<b>Addenda No.:</b>	<b>Addendum No. 02</b>
<b>Project:</b>	<b>Pueblo of Pojoaque Police Department Site/Security Improvements</b>
<b>Date Issued:</b>	<b>March 3, 2025</b>
This Addendum forms a part of the Contract Documents and modifies the Construction Documents dated May 2024 as noted below. Work not specifically deleted, modified, changed, or altered by this Addendum shall remain in effect as part of the Contract Documents. The Proposer must acknowledge receipt of this addendum on the Proposal Form. Failure to do so may subject Proposer to disqualification.

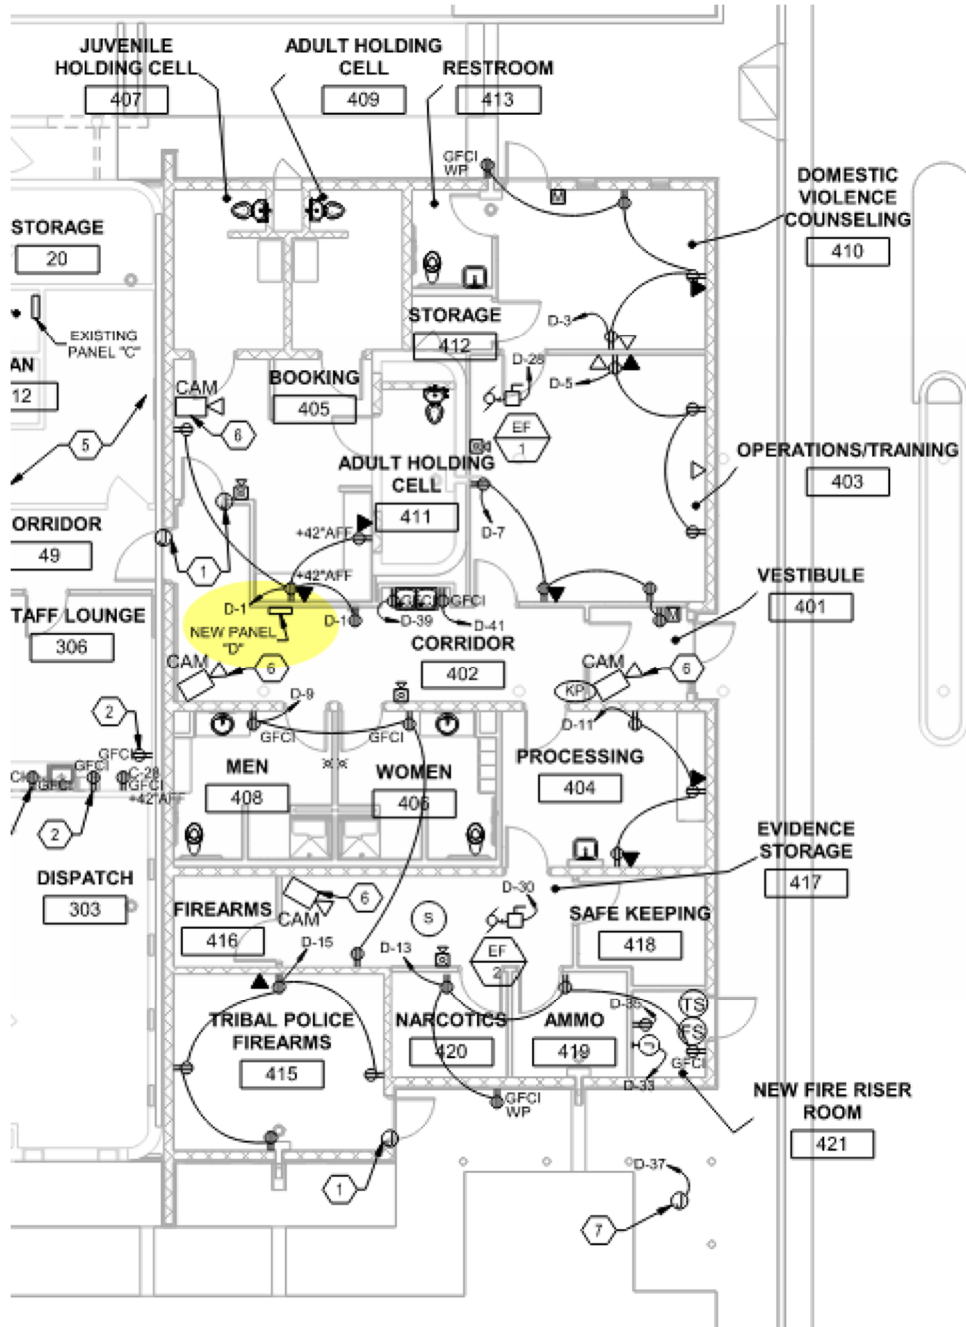
Item 03. Add the following electrical information to Construction Drawings Sheet AS-101 for Vehicle Gate Operators, Pedestrian Gate Operators, and Card Readers/Push Button/Keyed Access Controls (TBD by Owner). All electrical service will come from Existing Panel "D" located in

the existing building – See Partial Plan below for location. All new circuits will take up the “spare” panel locations D19-D24 (as needed, verify in field).

NOTE: Conduits routed beneath a driving surface shall be SCHEDULE 80 PVC and be concrete encased.

- G-1 Gate Operator will 20A/1, Verify VA (Volt-Ampere) with Operator
  - Feeder: 20A2G | 2#10,1#10G | 1” Conduit
  - Local Disconnect: Built-In
  - 8”x8”x6” enclosure, NEMA 3 lockable enclosure. Provide one (1) 120V quad receptacle in enclosure.

- CR-1 Card Reader, Verify VA (Volt-Ampere) with Operator
    - 1” Conduit with CAT6 Cable from Converter enclosure to device
    - Provide a bracket utilizing P1000 Unistrut directly adjacent to the gate post to accommodate the enclosure and card reader.

- G-2 Gate Operator will 20A/1, Verify VA (Volt-Ampere) with Operator
  - Feeder: 20A2G | 2#10,1#10G | 1” Conduit
  - Local Disconnect: Built-In
  - 8”x8”x6” enclosure, NEMA 3 lockable enclosure. Provide one (1) 120V quad receptacle in enclosure.

- CR-2 Card Reader, Verify VA (Volt-Ampere) with Operator
    - 1” Conduit with CAT6 Cable from Converter enclosure to device
    - Provide a bracket utilizing P1000 Unistrut directly adjacent to the gate post to accommodate the enclosure and card reader.

- G-3 Pedestrian Gate Operator 20A/1, Verify VA (Volt-Ampere) with Operator
  - Feeder: 20A2G | 2#10,1#10G | 1” Conduit
  - Local Disconnect: NEMA 5-20R
  - 8”x8”x6” enclosure, NEMA 3 lockable enclosure. Provide one (1) 120V duplex receptacle in enclosure.

- CR-3 Card Reader (TBD), Verify VA (Volt-Ampere) with Operator
    - 1” Conduit with CAT6 Cable from Converter enclosure to device
    - Provide a bracket utilizing P1000 Unistrut directly adjacent to the gate post to accommodate the enclosure and card reader.

- G-4 Pedestrian Gate Operator 20A/1, Verify VA (Volt-Ampere) with Operator
  - Feeder: 20A2G | 2#10,1#10G | 1” Conduit
  - Local Disconnect: NEMA 5-20R
  - 8”x8”x6” enclosure, NEMA 3 lockable enclosure. Provide one (1) 120V duplex receptacle in enclosure.

- CR-4 Card Reader (TBD), Verify VA (Volt-Ampere) with Operator
    - 1” Conduit with CAT6 Cable from Converter enclosure to device
    - Provide a bracket utilizing P1000 Unistrut directly adjacent to the gate post to accommodate the enclosure and card reader.

**AS-401**

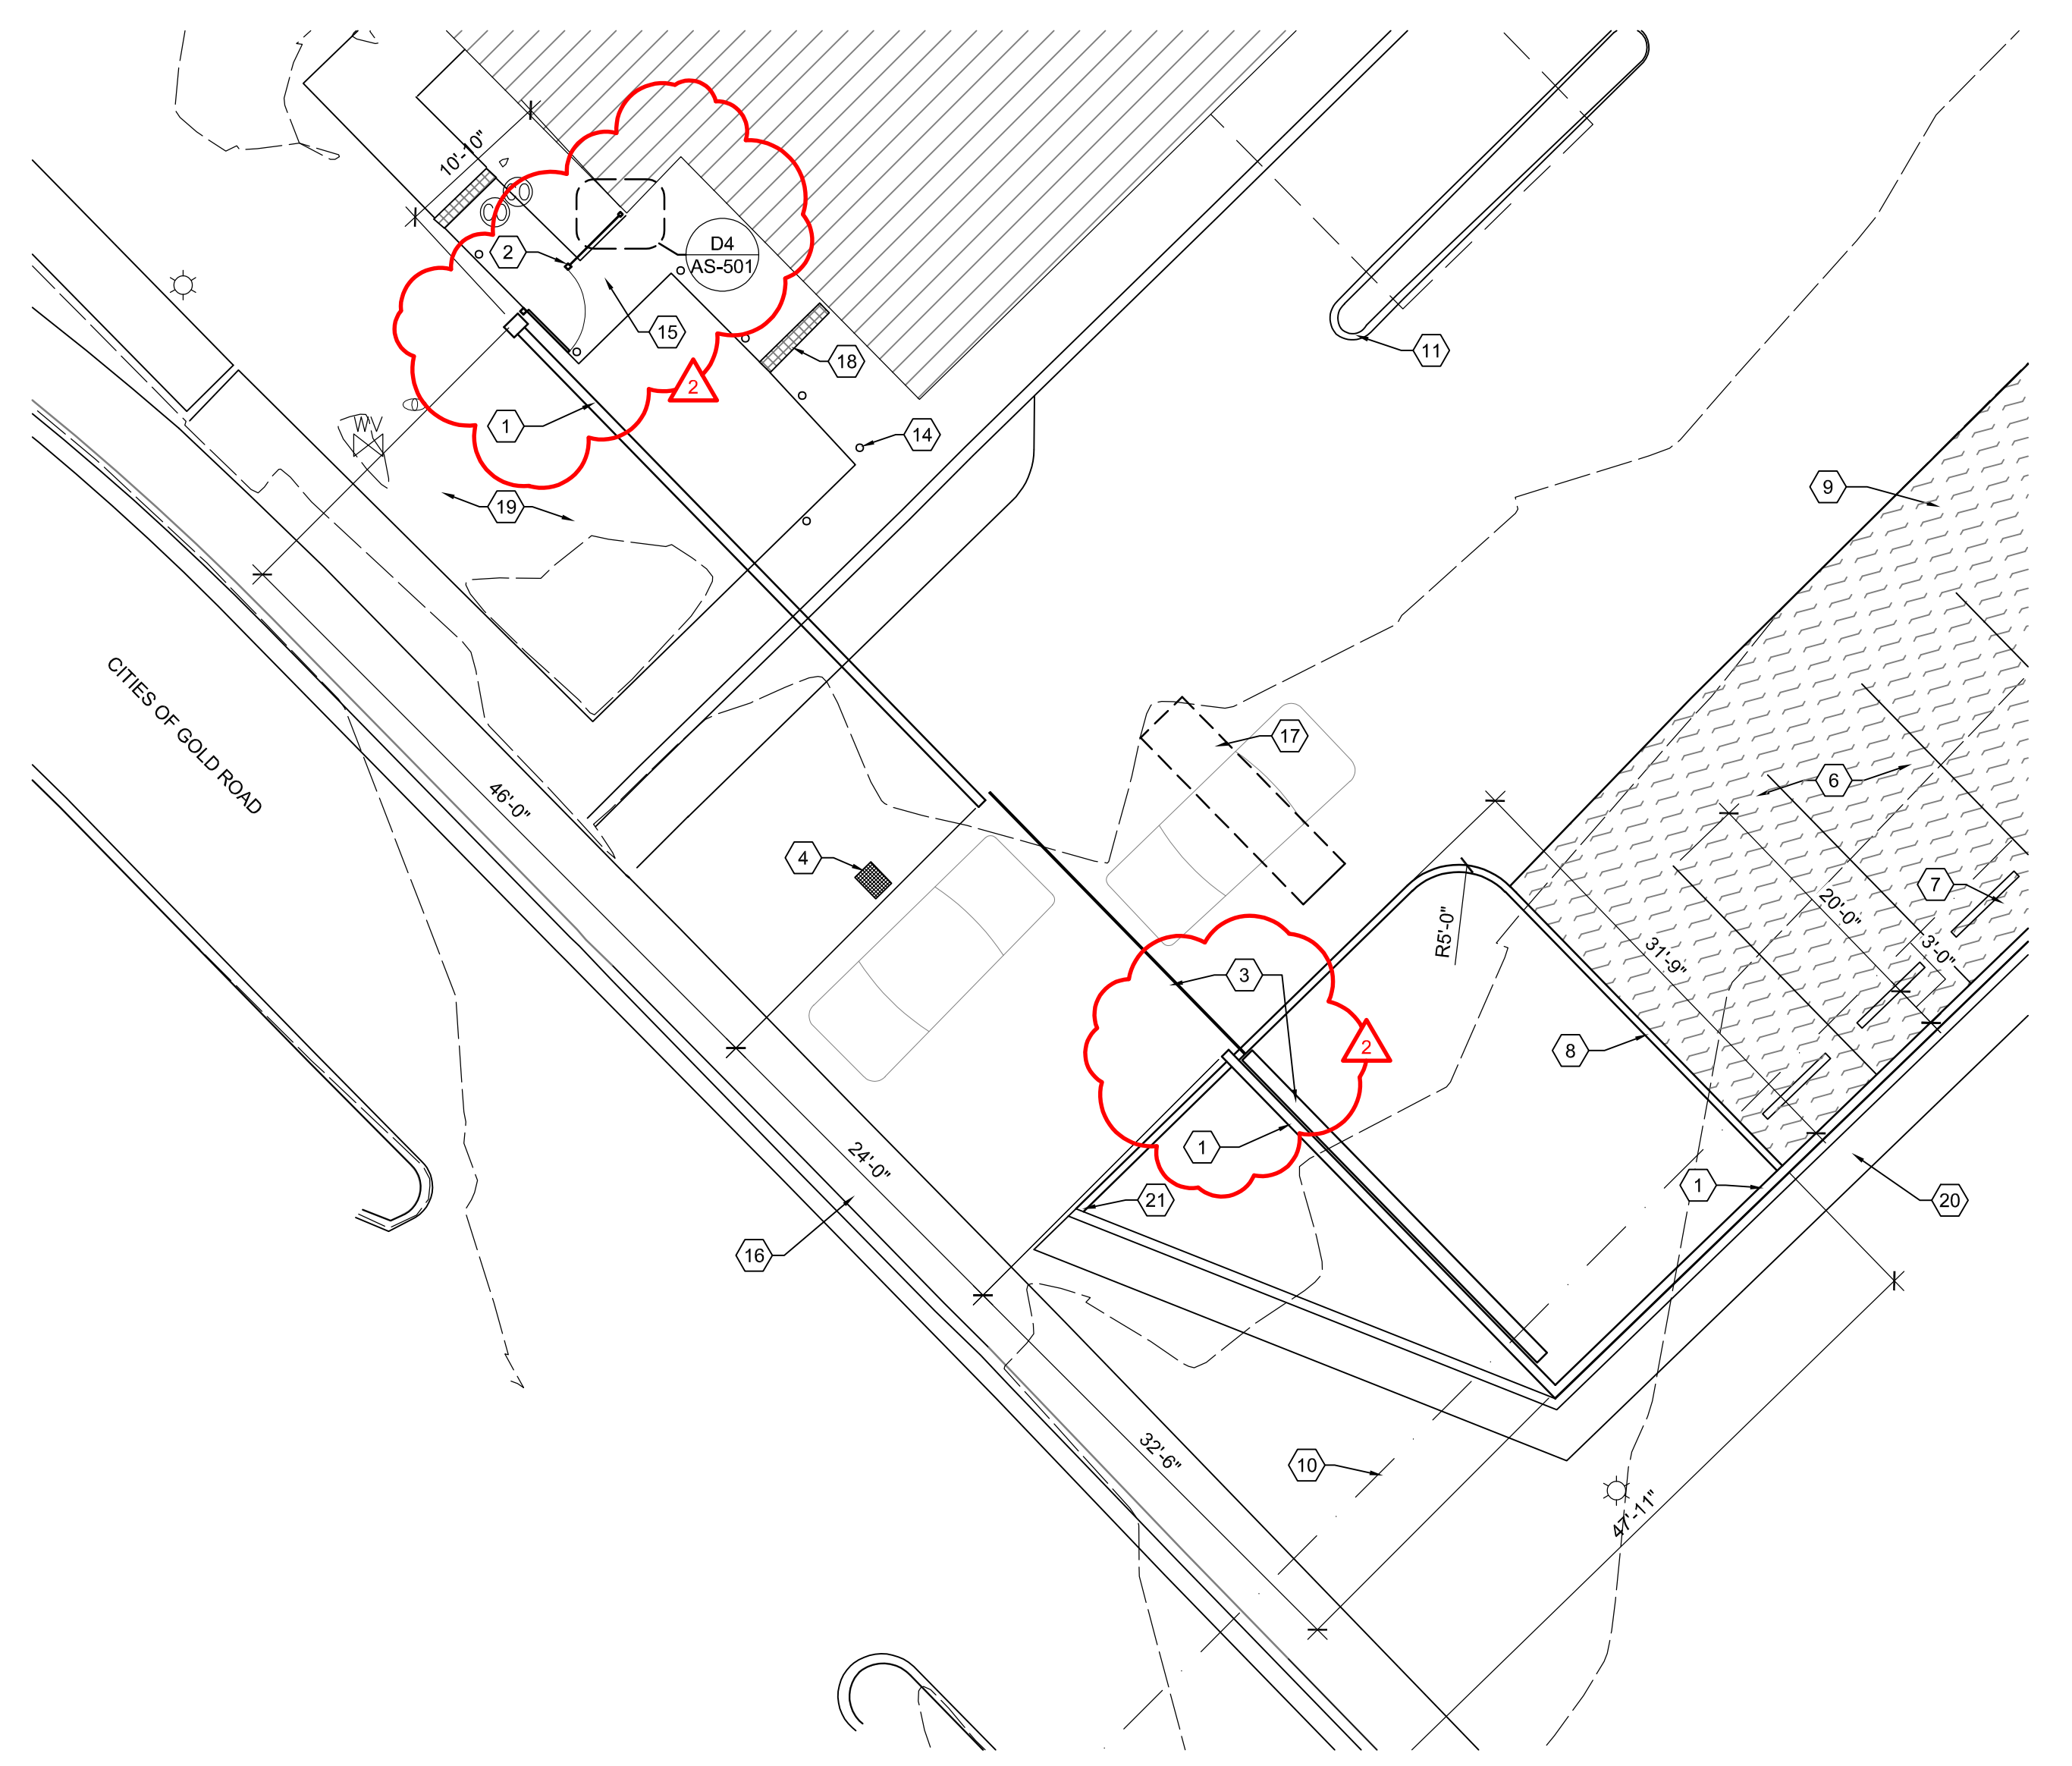
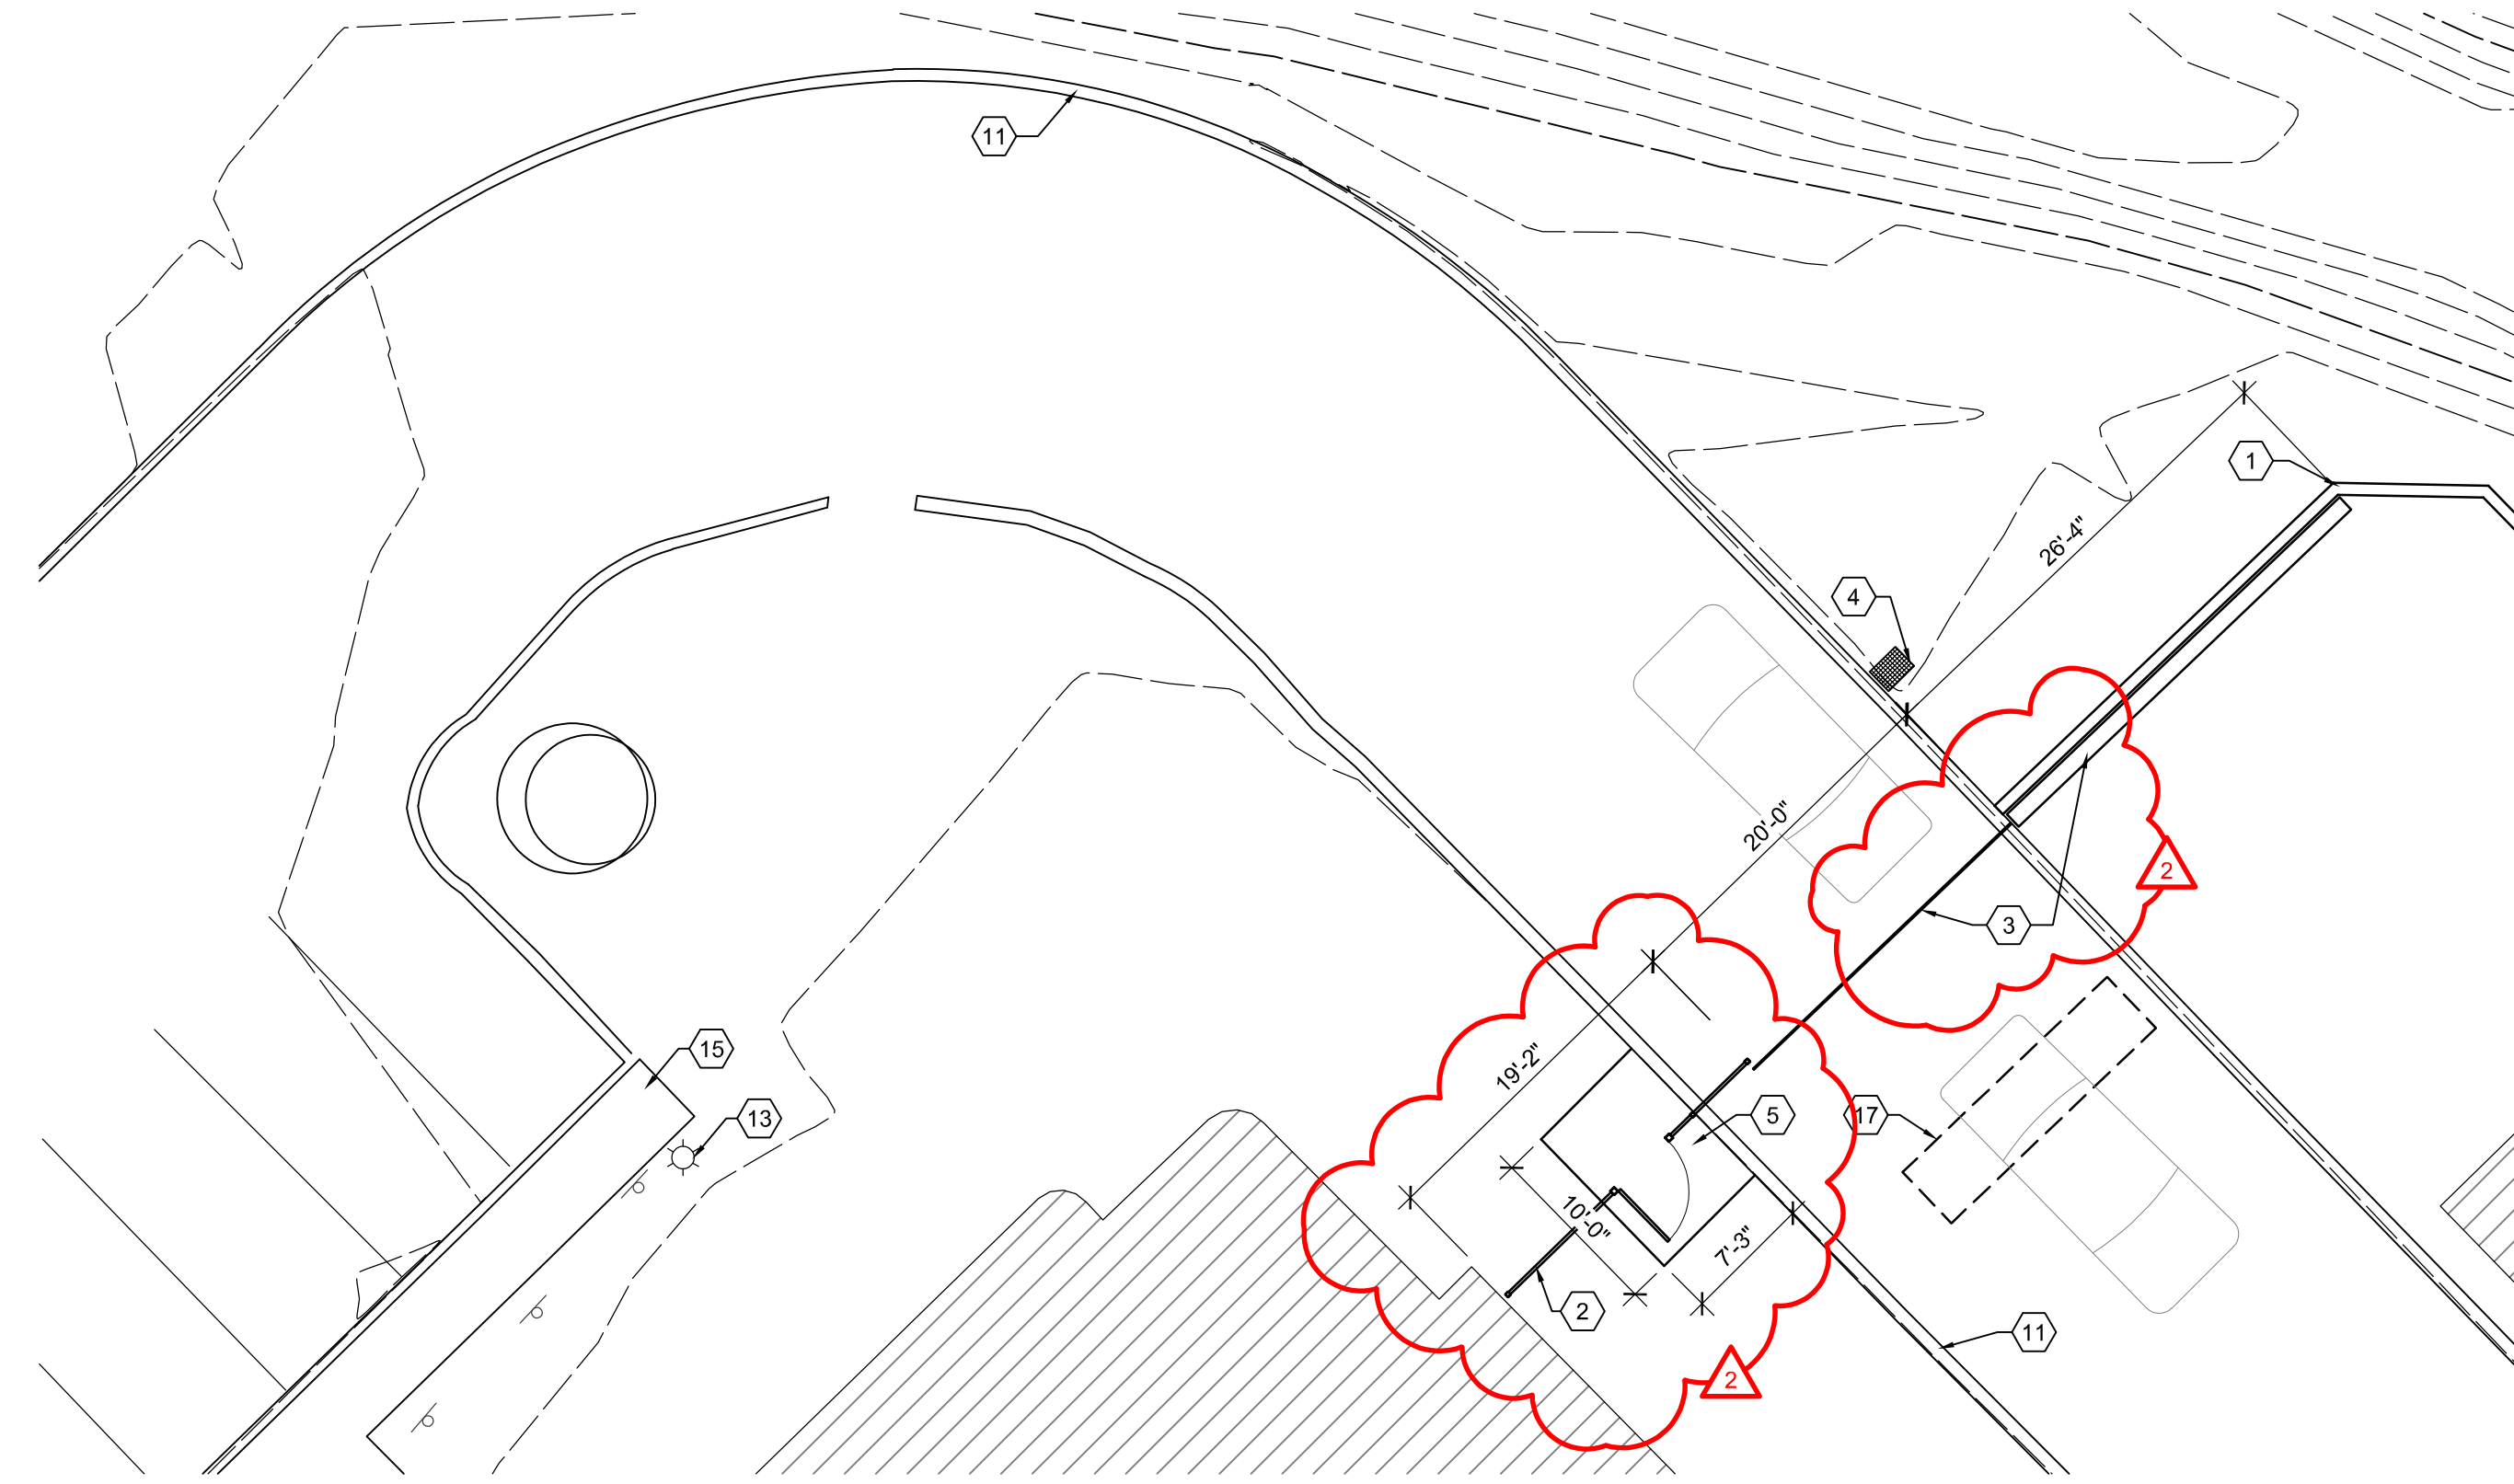
Q: *From my understanding you need cantilever slide gates for two different entrances. I see that you want the frame to be 4"x2" but what height would you like this to be? We can go as tall as 7'6" which will be close to 8' installed. I also need the opening width for each gate.*

Q: *For the pedestrian gate, what height and opening width will this be?*

Q: *Were there any other materials needed besides the two slide gates, one pedestrian gate, and automation systems?*

R: **See revised sheet AS-401**

R: **See revised sheet AS-401**

R: **See revised sheet AS-401**

- 3. NEW MOTORIZED VEHICLE ENCLOSED TRACK AND CANTILEVER GATE, GATE HEIGHT SHALL BE 8'-0", REFER TO ENLARGED PLANS FOR GATE WIDTH AND SPEC NOTES ON SHEET AS-101.
